HOMES NSW

29 FLORIDA STREET  
SYLVANIA (SSD-83258708)

RESPONSE TO SUBMISSIONS

REVISION 04

MASSING PRESENTED AS PART OF SSDA LODGEMENT

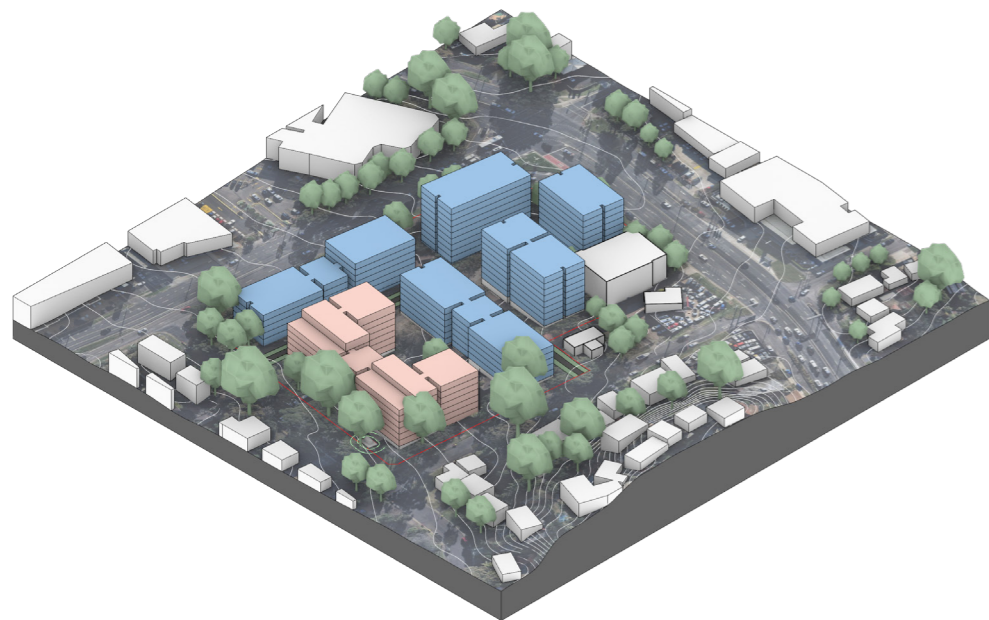
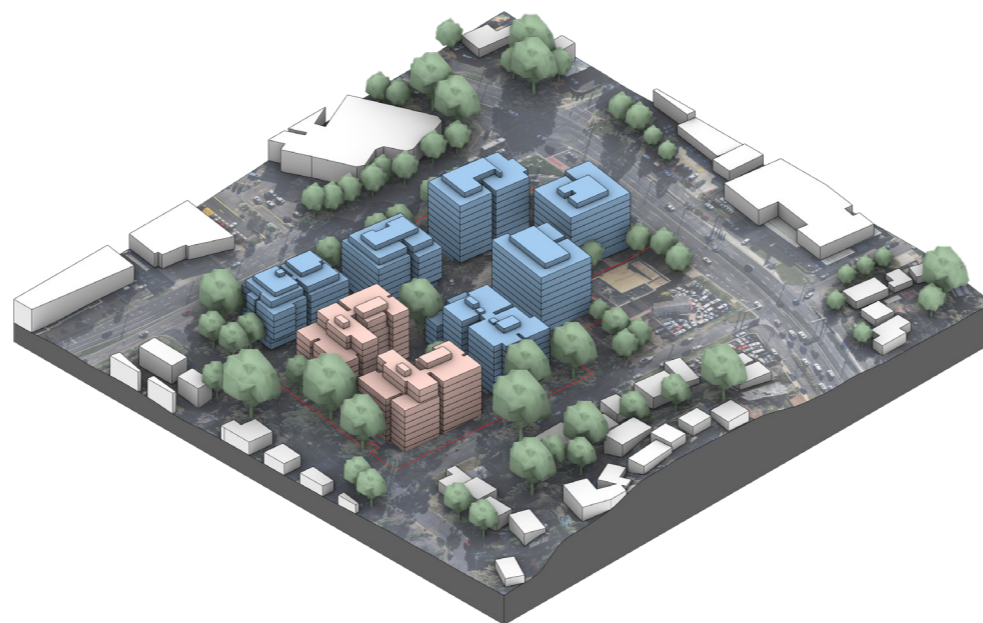
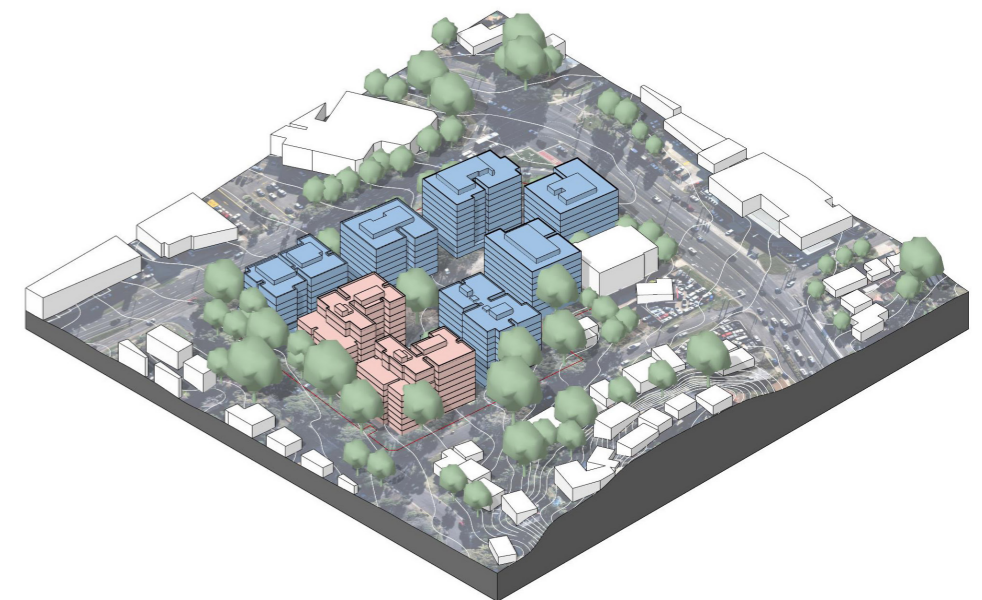
2.1	<p>To minimise the bulk and scale of the proposal, overshadowing impacts to 16 to 26 Pembroke Street and to improve the transition to the adjoining R3 Medium Density Residential and R2 Low Density Residential zoned areas, consideration should be given to redistributing building mass to the north of the site and increase building heights fronting Princes Highway and Port Hacking Road to allow for lower building heights along Pembroke Street and Florida Street.</p>	<p>While options involving greater height were explored during the design process and through the SDRP review, the design team prioritised a built form outcome that could deliver housing within the existing planning framework, enabling timely delivery while minimising the need for a future planning proposal. The distribution of built form across the site has been carefully considered in response to staging constraints and the physical characteristics of the site. The staged delivery of the project places particular limitations on the location and configuration of the social housing component, which is required to be delivered within the south-eastern portion of the site. This area is further constrained by existing site services, established road alignments, and significant retained trees. These conditions limit the opportunities to redistribute built form across the site without creating adverse impacts in terms of perceived bulk and scale, particularly when viewed from Pembroke Street.</p> <p>In response to SDRP feedback, the design has been refined to reduce the apparent scale and massing of the social housing buildings while maintaining the required housing yield. These refinements focus on breaking down the building form and redistributing height within the available envelope to moderate bulk when perceived from the public domain. As a result, only minor localised exceedances of the 28.6m height plane remain. These exceedances do not result in adverse amenity impacts to neighbouring properties or internal communal spaces, and compliance with the solar access provisions of the ADG is maintained. The proposed distribution of height across the development therefore represents a balanced outcome between planning controls, site constraints and the need to deliver essential housing. Importantly, the limited height exceedances do not compromise the development potential of adjoining sites along Pembroke Street, which retain the capacity to be developed in accordance with the applicable planning controls.</p> <p>Adjustments to setbacks and built form arising from the SDRP process have resulted in a more articulated street interface and a reduction in perceived bulk along Pembroke Street. These changes improve the transition of scale to the surrounding context while maintaining the project's housing delivery objectives. The resulting built form achieves a balanced relationship with the surrounding streets and minimises impacts on neighbouring properties. Overshadowing impacts are addressed in further detail in response to Item 4.1.</p>

### MARKET BUILDING 1B

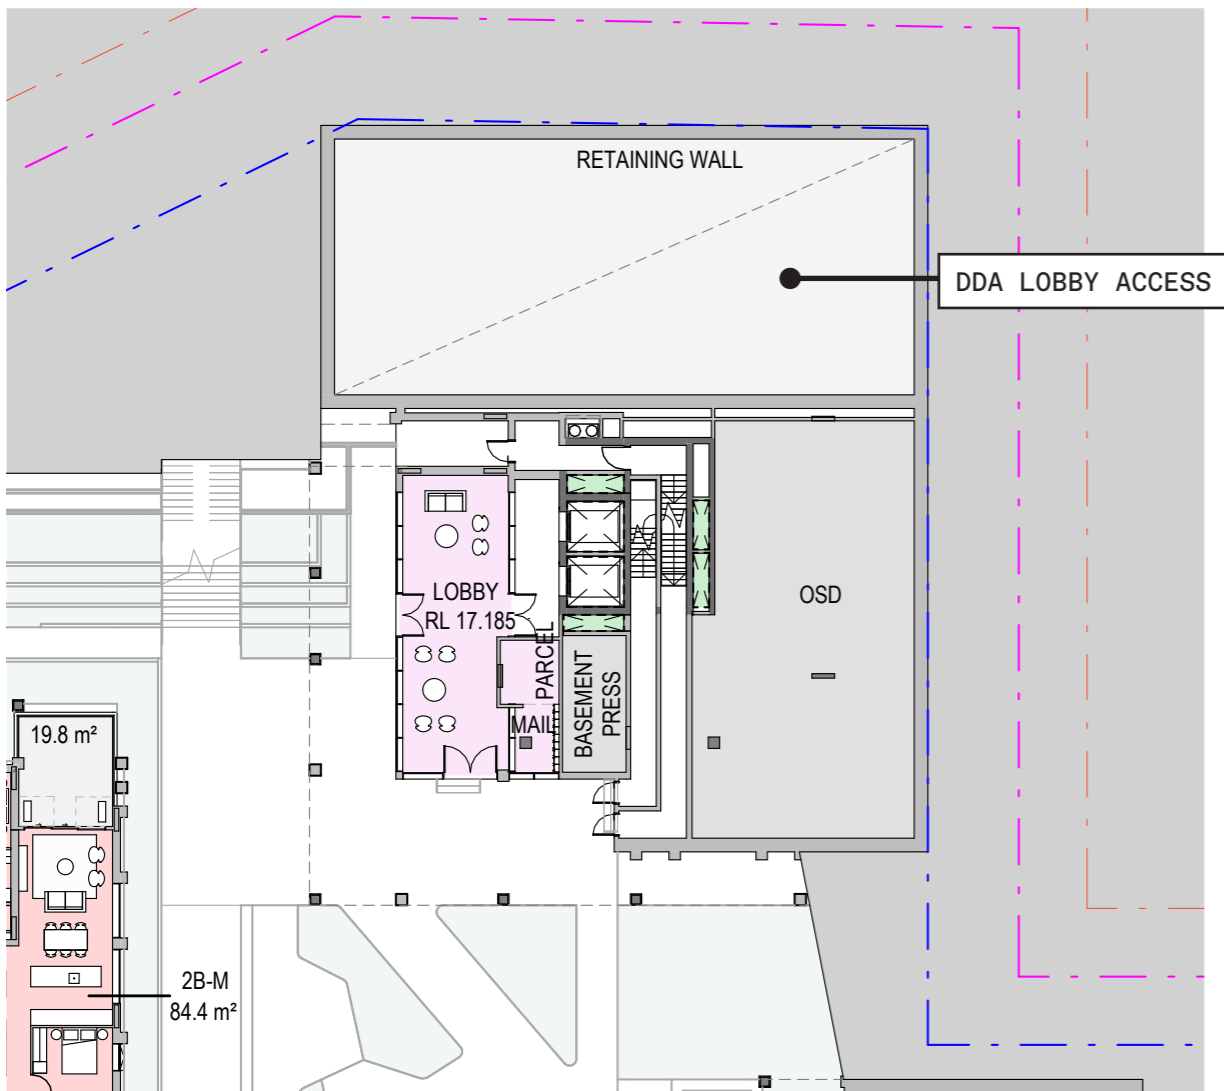
NO.	ISSUE RAISED	RESPONSE
BUILT FORM & URBAN DESIGN		
2.2	<p>The design of ground floor lobbies is to be reviewed to improve amenity, including:</p> <ul style="list-style-type: none"> <li>a) minimising the number of dead ends and increasing passive surveillance opportunities</li> <li>b) minimising reliance on artificial lighting and maximising access for natural light</li> <li>c) ensuring accessible access is provided to all lobbies.</li> </ul>	<p>Minor adjustments to planning of residential ground floor lobbies have been made to maximise access to natural light from ground floor entries where possible. These changes have been proposed for Market Building 1B and 3A and the Social Housing building to improve the entry and arrival experience, maximising views from residential apartment doors.</p> <p>The sloping topography of the site complicates the scheme's ability to provide views out of ground floor lobbies in two directions. Activation at the lower levels does in some cases result in lobbies that address communal spaces, but are buried within topography on the adjacent sides (such as Market Building 1). To counteract this, lobbies are generally shallow, minimising long corridors into lifts and reducing the depth from lift entries to the facade line. Where possible, lounge areas and informal areas are provided at building entries.</p> <p>All residential ground floor lobbies are accessible either directly from communal open spaces, adjacent shared footpath zones or through indicated alternative routes within close proximity of the main entry. In the social housing development, DDA access is provided from Florida Street as shown in the diagram below and not provided at the lower level adjacent to the new internal road.</p>

Diagrammatic sun eye view studies highlighting each individual facade to better represent solar access.

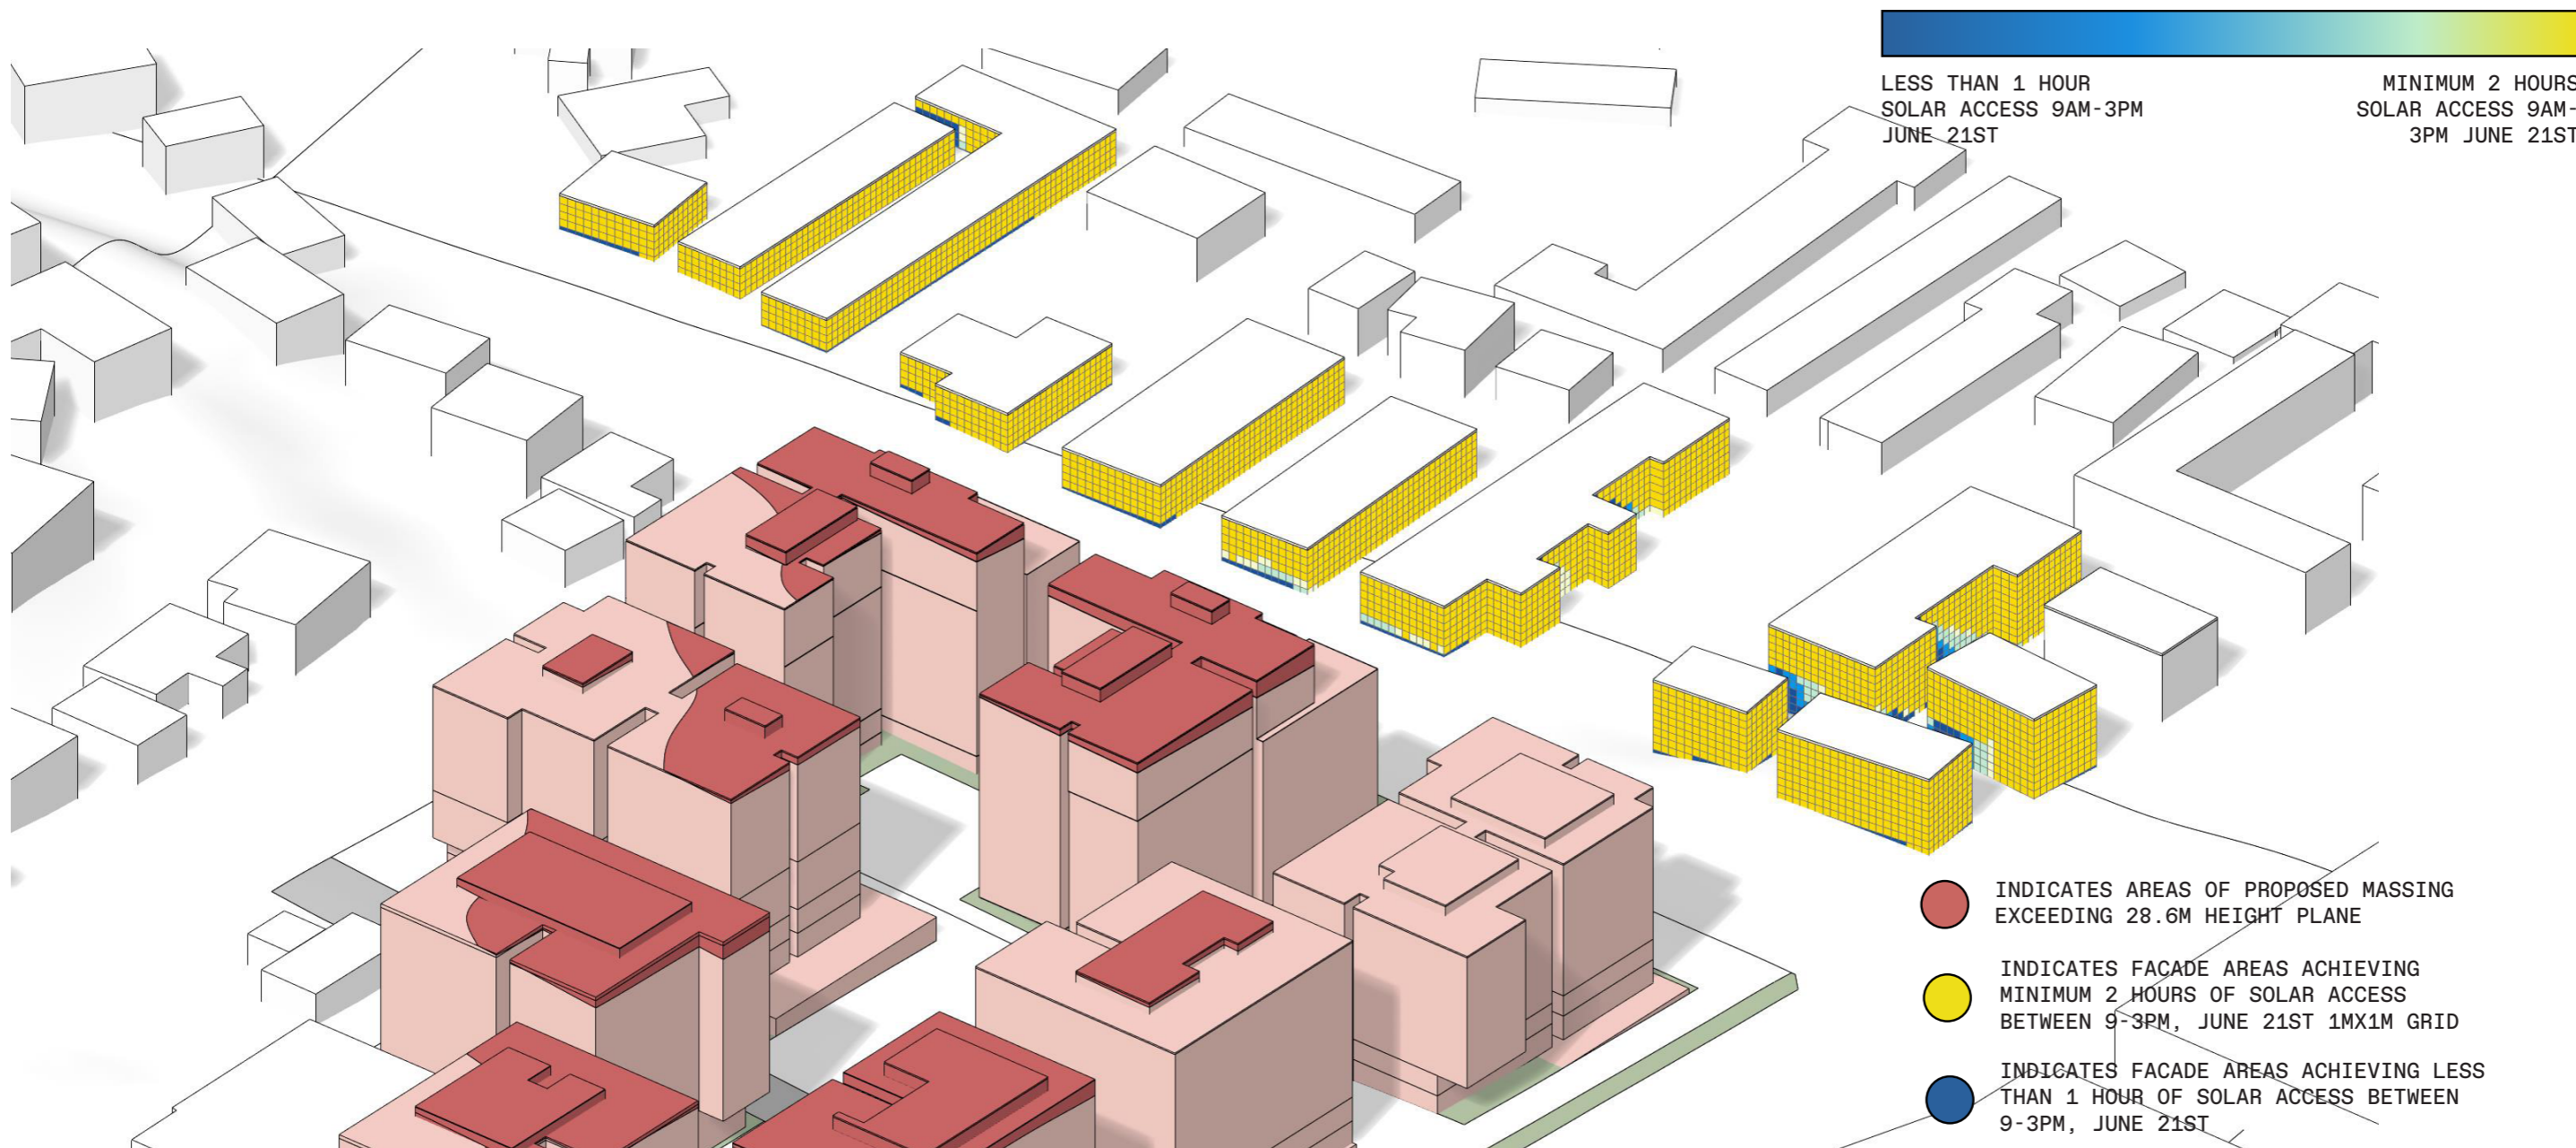
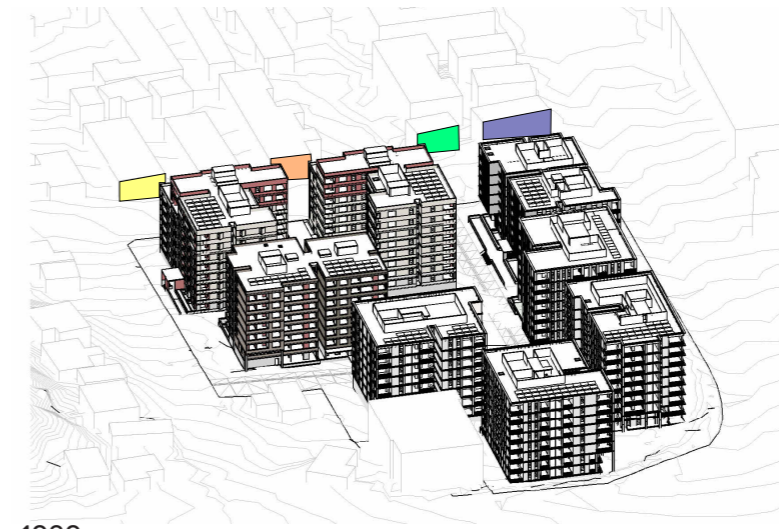
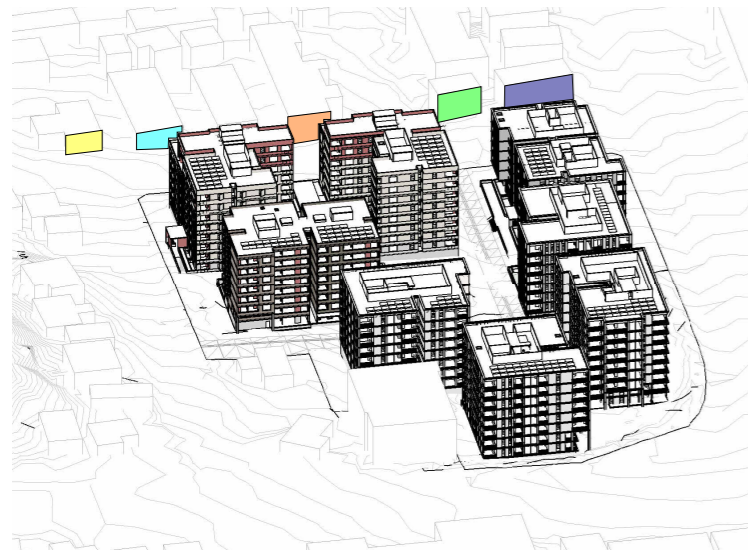
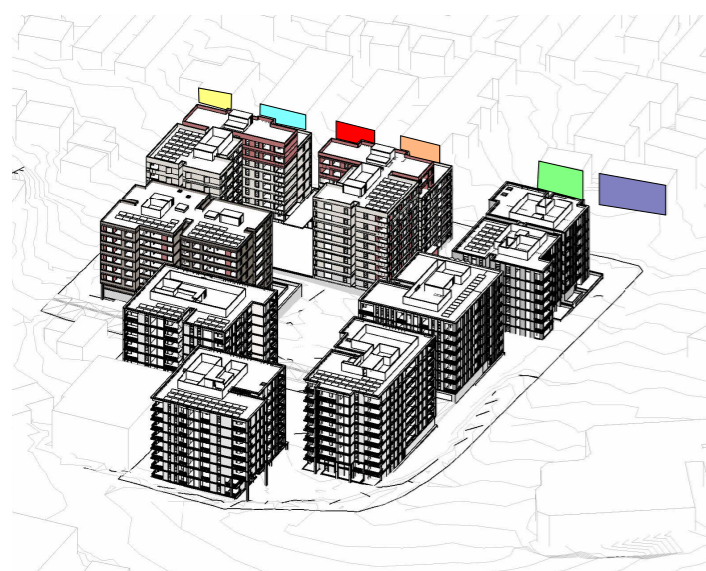
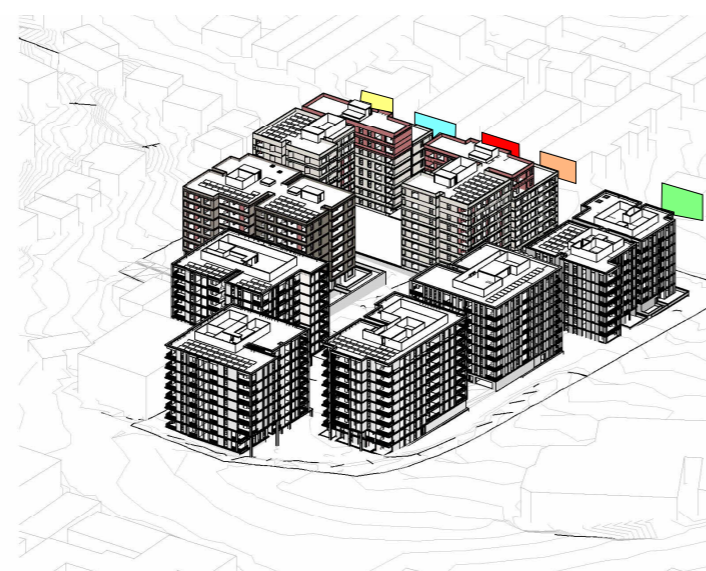
NO.	ISSUE RAISED	RESPONSE
<b>BUILT FORM &amp; URBAN DESIGN</b>		
4.1	<p>There are inconsistencies between the solar access diagram and sun-eye views plan making it difficult to accurately assess the extent of overshadowing generated by the proposed height exceedance on adjoining residential buildings on the southern side of Pembroke Road (i.e., 16 to 26 Pembroke Street).</p> <p>Please review and clarify the extent to which the proposed height exceedance contributes to overshadowing generated by the proposal.</p>	<p>The solar access diagram provided in the Architectural Design Report reflects the portions of facades of the properties along Pembroke Street that receive a minimum of 2 hours of direct sun between the hours of 9am - 3pm on June 21. This does not suggest that the development does not result in any additional overshadowing from current conditions, only that the required solar access to these sites based on ADG minimums is achieved. It is therefore not an assessment of the extent to which the height exceedance contributes to overshadowing of the neighbouring properties.</p> <p>The analysis has been undertaken based on information available to the design team at the time of submission - this included an extrapolated model of neighbouring buildings and topography based on ELVIS spatial data. The parametric analysis measures the facade based on a 1mx1m grid, at each 15 minute increment, it is therefore more granular and nuanced than the sun eye view studies which are not provided at such a fine increment and time period.</p> <p>To provide greater clarity, diagrams on the following page highlight each of the individual facades to give a clearer correlation between what is receiving sun at each time increment and associates this with the analysis provided in the report.</p>
